ATTACHMENT 2 to AEP:NRC:1137

PROPOSED, REVISED TECHNICAL SPECIFICATIONS PAGES

FOR DONALD C. COOK NUCLEAR PLANT UNITS 1 AND 2

FIGURE 2.1-1 REACTOR CORE SAFETY LIMITS

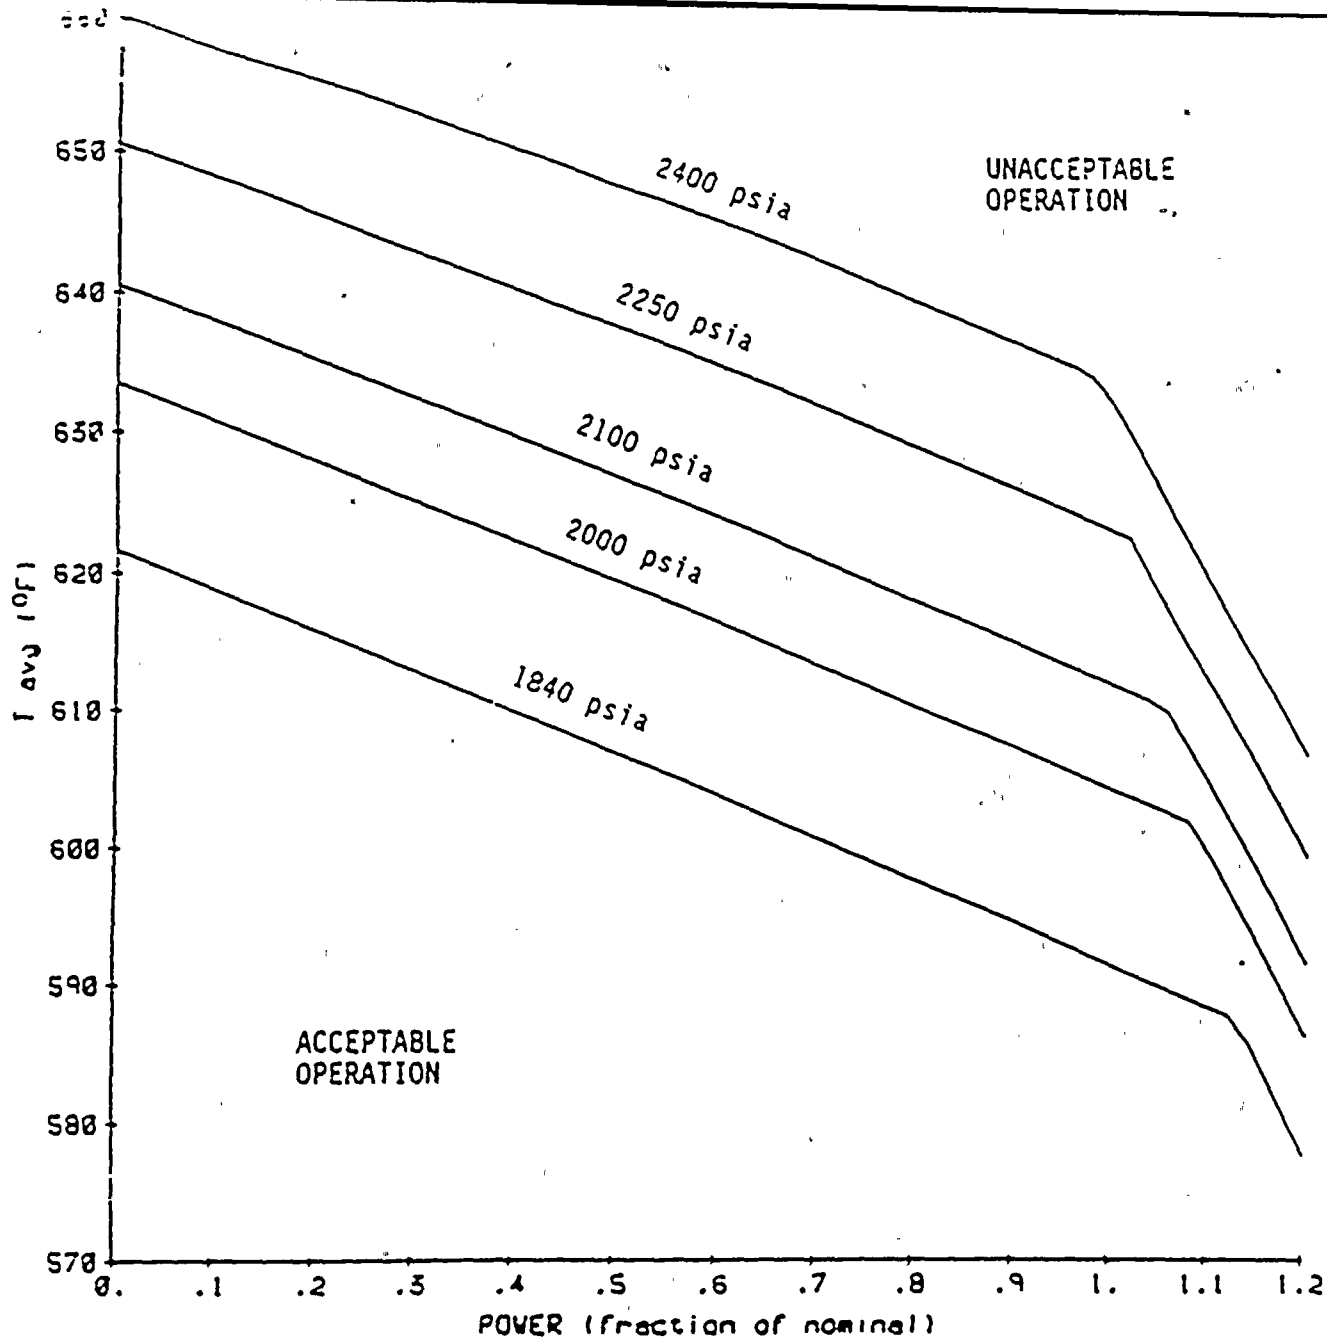
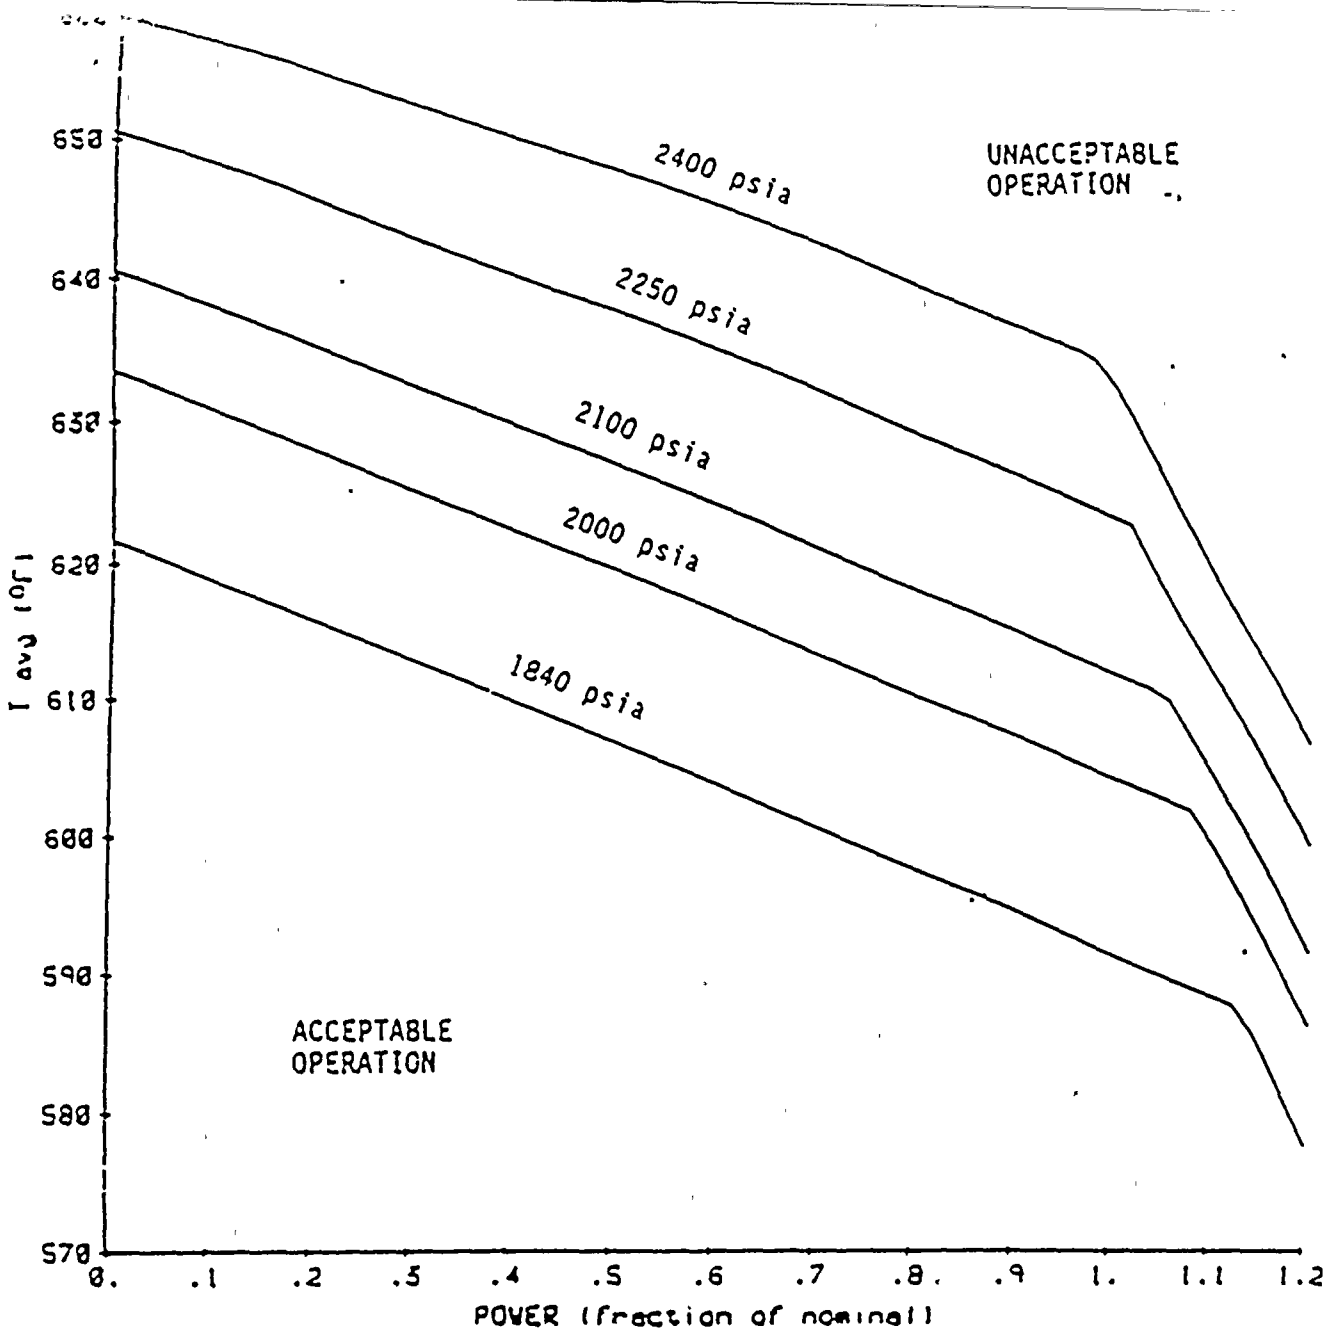
2.1.1 The combination of THERMAL POWER, pressurizer pressure, and the highest operating loop coolant average temperature ( $T_{avg}$ ) shall not exceed the limits shown in Figure 2.1-1 for 4 loop operation.

PRESSURE (PSIA)	BREAKPOINTS (FRACTION RATED THERMAL POWER, T-AVG IN DEGREES F)
1840	(0.0, 622.1), (1.13, 587.3), (1.20, 577.5)
2000	(0.0, 633.8), (1.08, 601.4), (1.20, 586.0)
2100	(0.0, 640.8), (1.06, 609.8), (1.20, 591.3)
2250	(0.0, 650.7), (1.02, 621.9), (1.20, 598.9)
2400	(0.0, 660.1), (0.98, 633.7), (1.20, 606.2)

1840	(0.0, 622.1), (1.13, 587.3), (1.20, 577.5)
2000	(0.0, 633.8), (1.08, 601.4), (1.20, 586.0)
2100	(0.0, 640.8), (1.06, 609.8), (1.20, 591.3)
2250	(0.0, 650.7), (1.02, 621.9), (1.20, 598.9)
2400	(0.0, 660.1), (0.98, 633.7), (1.20, 606.2)
